Feathercrest and Stone Ridge Lift Stations Upgrades-Ph 3 and 4: New Feathercrest Lift Station
Solicitation Number: CO-00310-SM
Job No.: 19-2502

ADDENDUM 1
Wednesday, June 3, 2020

FEATHERCREST AND STONE RIDGE LIFT STATIONS UPGRADES
SAWS JOB NO. 19-2502
ELECTRICAL SITE PLAN

San Antonio Water System
FEATHERCREST AND STONE RIDGE LIFT STATIONS UPGRADES SAWS JOB NO. 19-2502
LIFT STATION CONTROL DETAILS #1 PUMP CONTROL PANEL

BAR IS ONE INCH ON ORIGINAL DRAWING.
ONE INCH
DESIGNED: BD
DRAWN: SG
CHECKED: CG
REVIEWED: SM
Seq. of
Dwg. No. E-3
0535-013-01

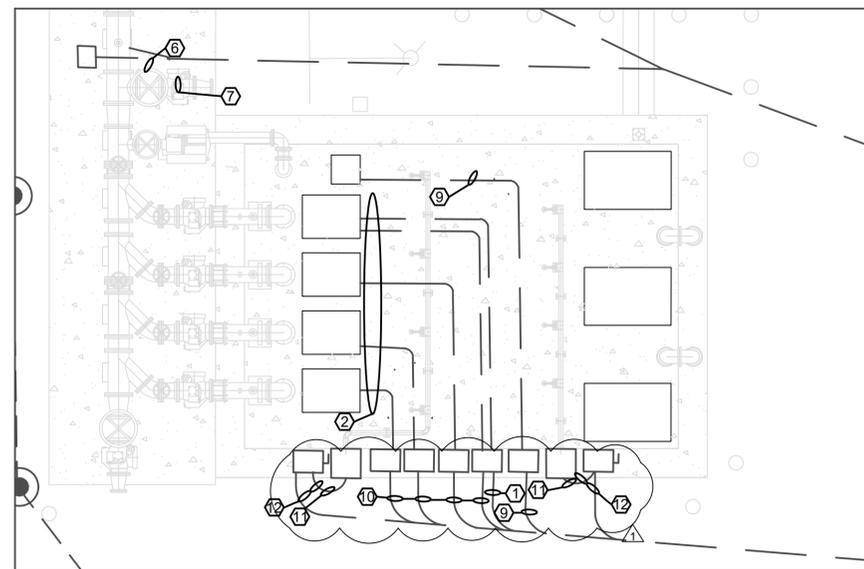
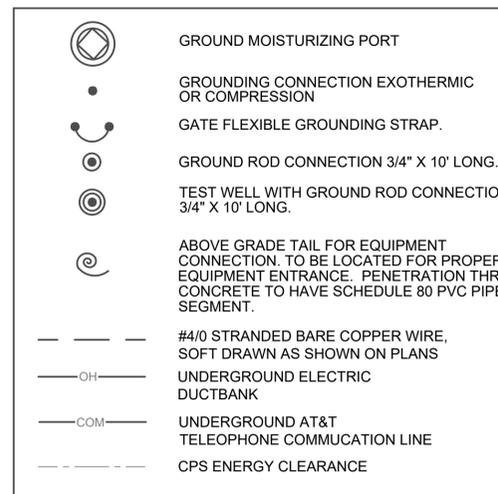
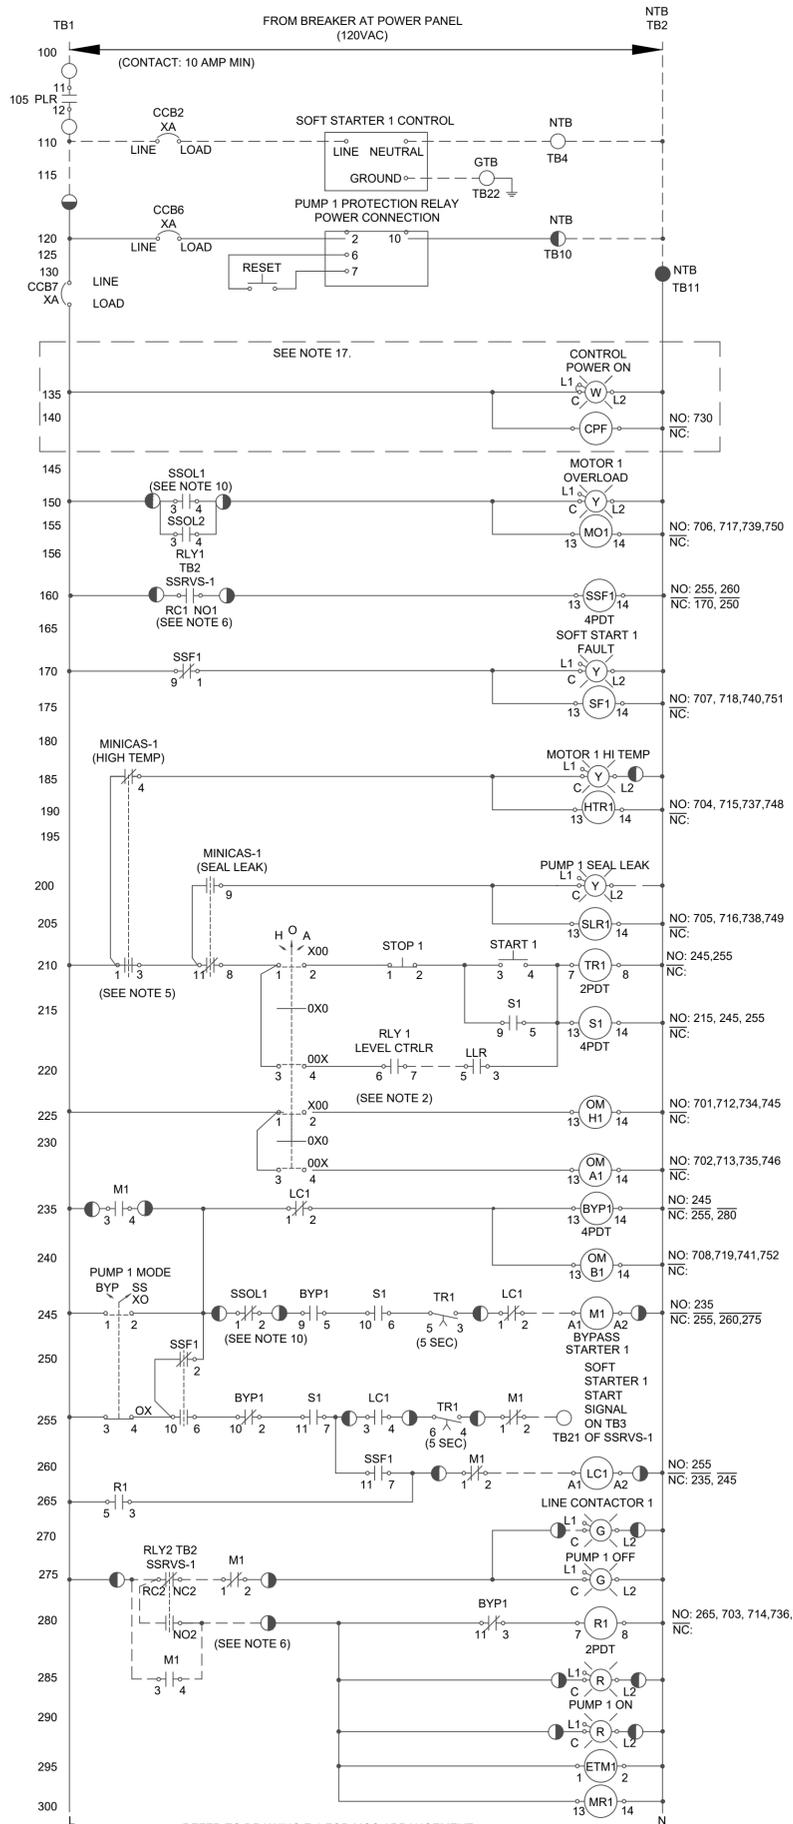
9. Sheet E-3 Keyed Note 4, Ductbank to Antenna tower is missing the coax cable for Cellular Antenna. Please clarify if it is to be routed in the spare conduit or if you require additional conduit.

10. Sheet E-3 keyed Note 7 calls for 2-3/4" for the heat trace feeder. However, Sheet E-6 Panel A schedule calls for 2#12 & 1#12 G in 1" conduit. Please clarify the conduit size to be utilized as well as the wire sizes. It seems it should be 1" conduit with 2#10 and 1#12.

11. Sheet E-3 Keyed Note # 2 refers shows 3" conduit for pump power and spares, whereas Keyed Note #10 as well as One-line diagram on Sheet E-2 shows these to be 2" conduits. Please clarify whether 2" or 3" conduit is to be used.

12. Sheet E-3 Keyed Note #11 refers to Sheet E-6 Detail E for cables sizes for the Odor Control Blower Controls. Detail E on Sheet E-6 is the panel schedule. Please clarify the required control cables.

13. Sheet E-3 Keyed Note #12 calls for 2-1" conduit for Odor Control Blower Power from the MCC to disconnect with (1) spare in the ductbank. However, it is also indicated at the Lift Station between the disconnect and the Odor Control Blower. Please clarify if the spare conduit required between the disconnect switch and the blower.

Response: Refer to Changes to the Plans items #1 and #3 below.

Response: Refer to Changes to the Plans items #1 and #3 below.

Response: Refer to Changes to the Plans item #1 below.

Response: Refer to Changes to the Plans item #1 below.

Response: Refer to Changes to the Plans item #1 below.

- 1. Dwg E-3:** Replace entire sheet with the attached.
- 2. Dwg. E-4:** Replace entire sheet with the attached.
- 3. Dwg. E-6:**
 - a. Detail C:
 - i. Broadband Radio, Remove “See note 2 & 4.”
 - ii. Add note 4: “Mount Cellular Antenna 8’ above grade on antenna mast. Use LMR-900 outdoor rated coaxial cable for connection.”
 - b. Detail E:
 - i. Circuit 4, revise wire to: “2-#10, 1-#10 GND.”
- 4. Dwg E-7:**
 - a. Detail A:
 - i. Ground connection from Panel to Tower: Remove callout labeled: “See notes 9 & 18.” Replace with See note 18.”
 - ii. Remove all callouts regarding note 9.
- 5. Dwg E-8:** Replace entire sheet with the attached.

Seq. of
Dwg. No. E-4
0535-013-01

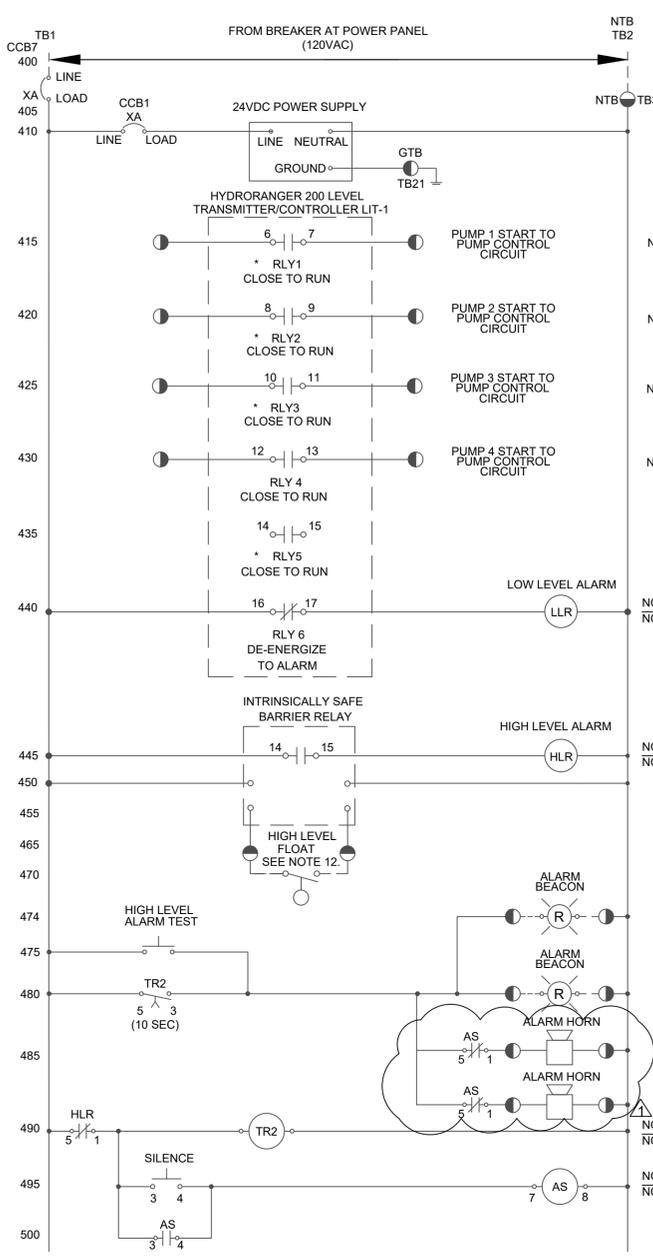
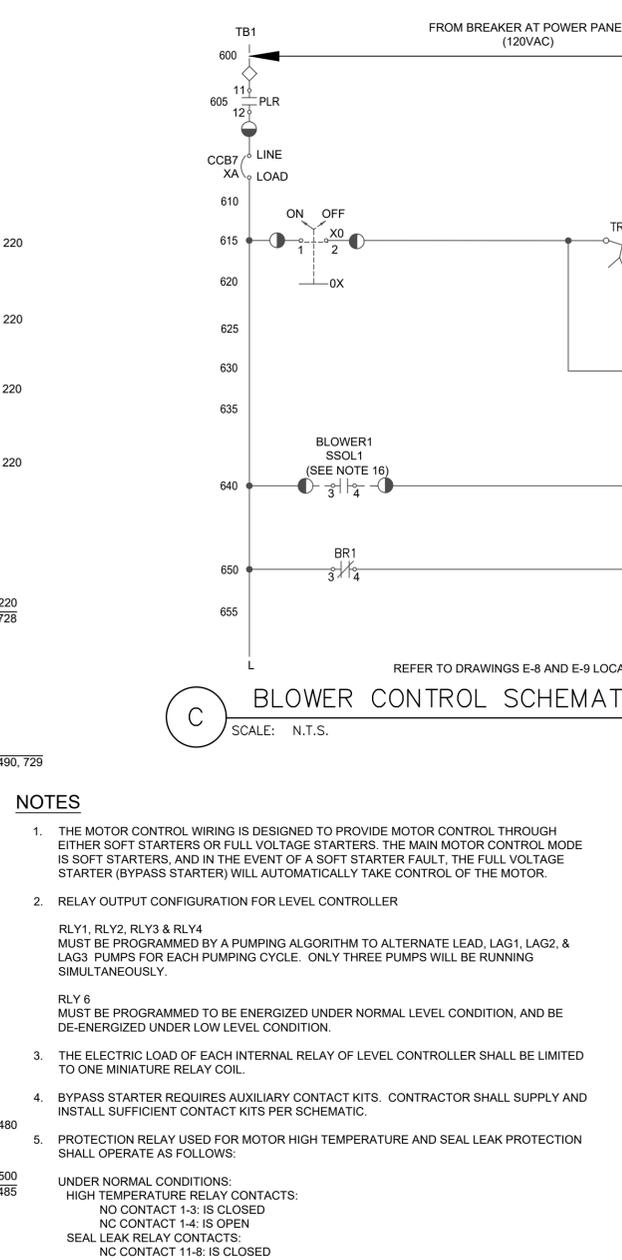
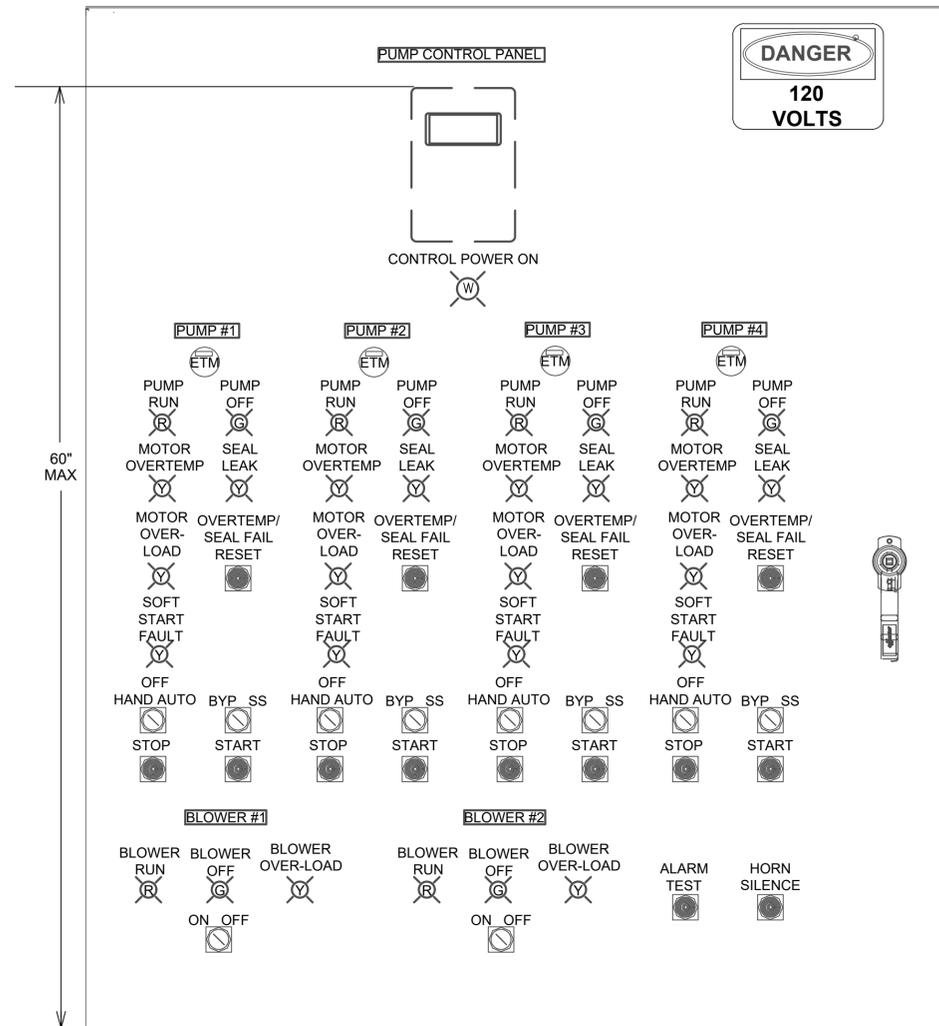
Response: Refer to Changes to the Plans item #5 below.
- 7. Please provide manufacturer & catalog # regarding the beacon Alarm Light with Horn shown on Sheet E-8.**

Response: Refer to Changes to the Plans item #2 and #5 below.
- 8. Sheet E-6 Detail C, Broadband Radio refers to note 2 & 4, there is no note 4, would this be referring to note #4? Please clarify.**

- ONLY ONE CONTROL POWER STATUS CIRCUIT REQUIRED
- ALARM BEACONS SHALL BE EDWARDS MODEL 125STRNR120A (RED).
- ALARM HORNS SHALL BE EDWARDS MODEL 876-N5.

Seq. of
 Dwg. No. E-8

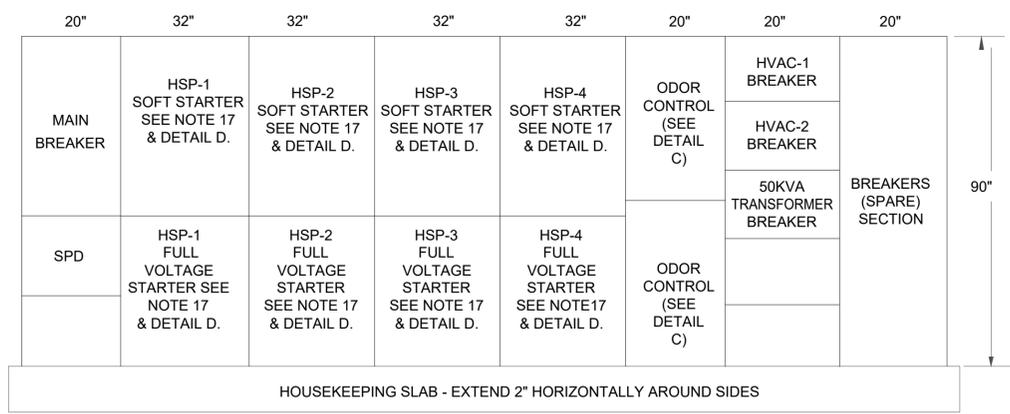
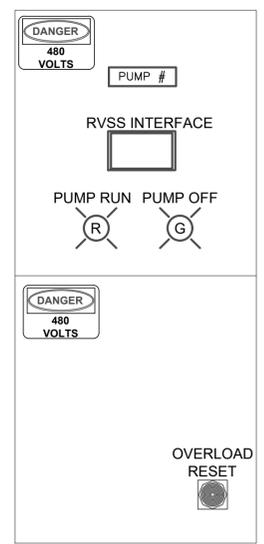
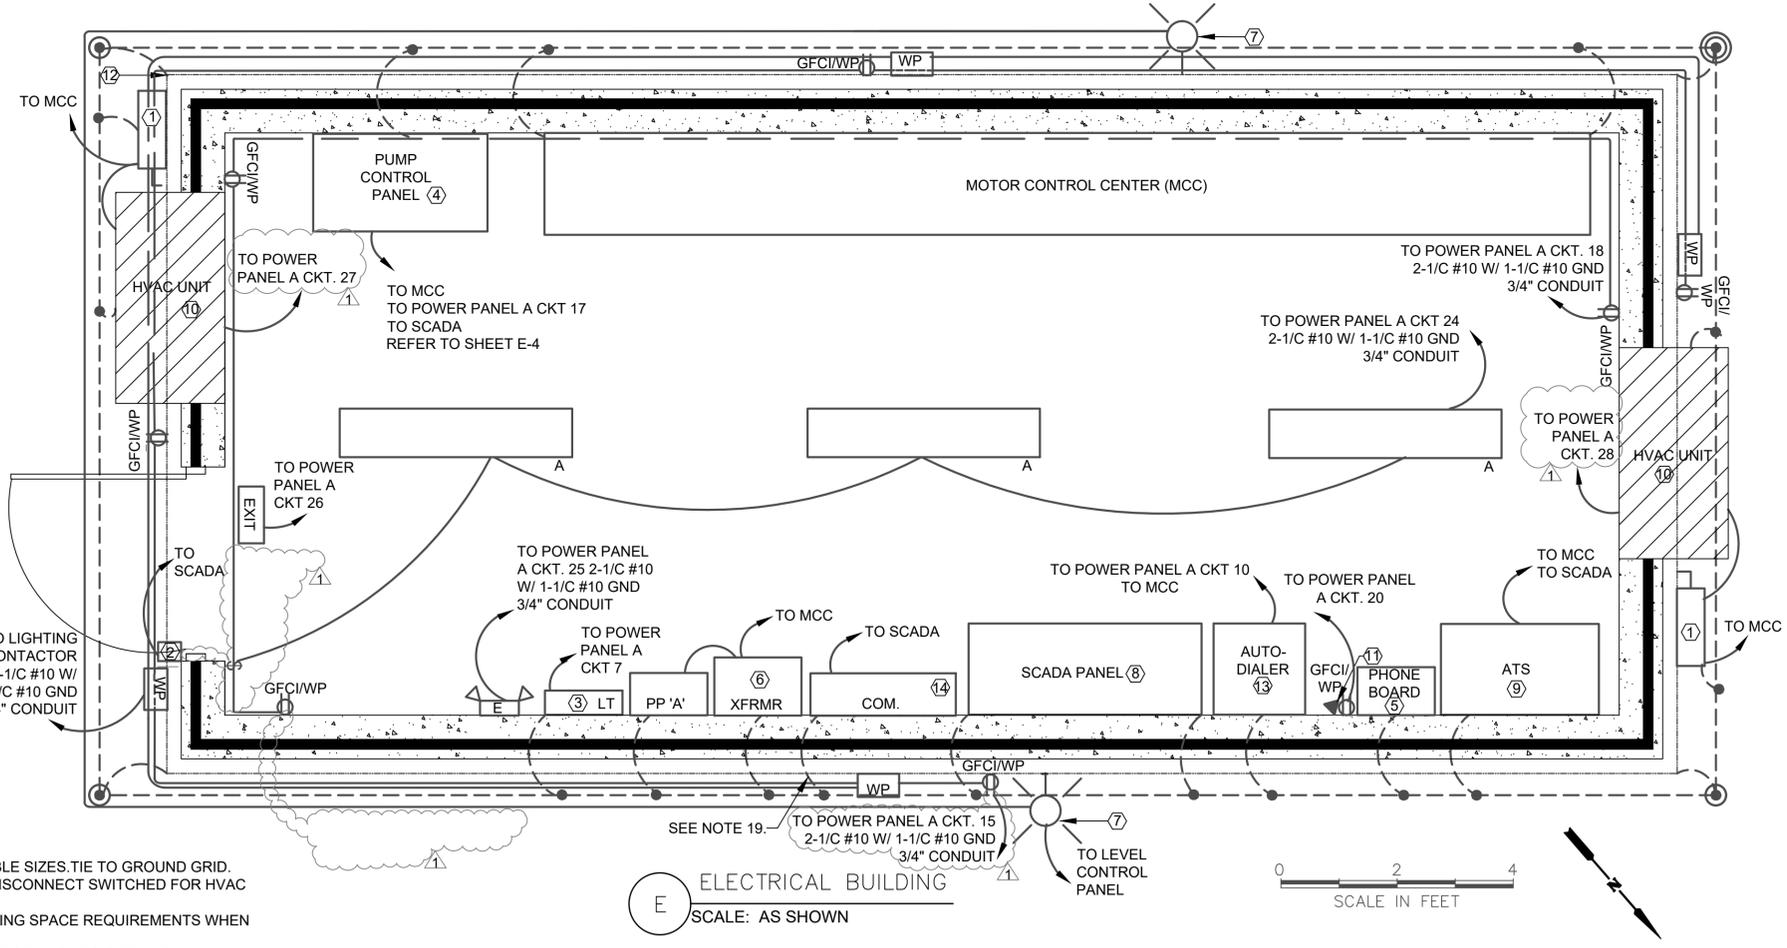
Response: Note is correct. It is referenced at the top of the detail A near the antenna.
- 3. Sheet E-6 Panel Schedule A Circuit #21 shows to go to building intrusion sensor as well as shown on E-8, Lift Building layout. There seems to be no specification regarding the intrusion sensor required. Please provide additional information regarding the intrusion sensor that requires 120V power supply**

Response: Refer to Changes to the Plans item #1 below.
- 6. E-8 general note #10 state "ALL DEVICES SHOWN ON THE PID'S AND INTERCONNECT DRAWINGS SHALL BE INSTALLED WITH CONDUIT/CABLES WHETHER SHOWN ON THE FLOOR PLAN OR NOT". However, there is no clarification on the wire sizes required. Please clarify the wire sizes required as design drawings seems to use both #12 and #10 being utilized for control conductors.**

16. Sheet E-8 shows inputs from both wall mounted HVAC Units to SCADA. However, E-11 shows a single input to SCADA from Electrical room Temperature transmitter. Please review and advise if SCADA input is from an Ambient temperature Sensor or temperature sensors internal to the HVAC units.

Response: Sensor to be powered by 24VDC supply in SCADA Panel. See Changes to the Specification item #1 and Changes to the Plans item #5 below.
- 4. E-2 Site drawings show wire insulations to be THWN which contradicts specification Section 16120 2.1.C. Please clarify which is to be used.**

Response: SCADA input is from an Ambient Temperature Sensor. Refer to Changes to the Plans items #5 below.

- 8. GROUND ROD RESISTANCE TO BE 5 OHMS OR LESS.
 - 9. GROUND RODS TO BE SPACED AT LEAST 20' APART.
 - 10. ALL DEVICES SHOWN ON THE PID'S AND INTERCONNECT DRAWINGS SHALL BE INSTALLED WITH CONDUIT/CABLES WHETHER SHOWN ON THE FLOOR PLAN OR NOT. DIGITAL I/O FOR SCADA SHALL BE 2-#12 W/ #12 GND. ANALOG I/O FOR SCADA SHALL BE #16 TW/SH/PR. POWER CIRCUITS SHALL BE 2-#10 W/ #10 GND, 3/4" CONDUIT MINIMUM.
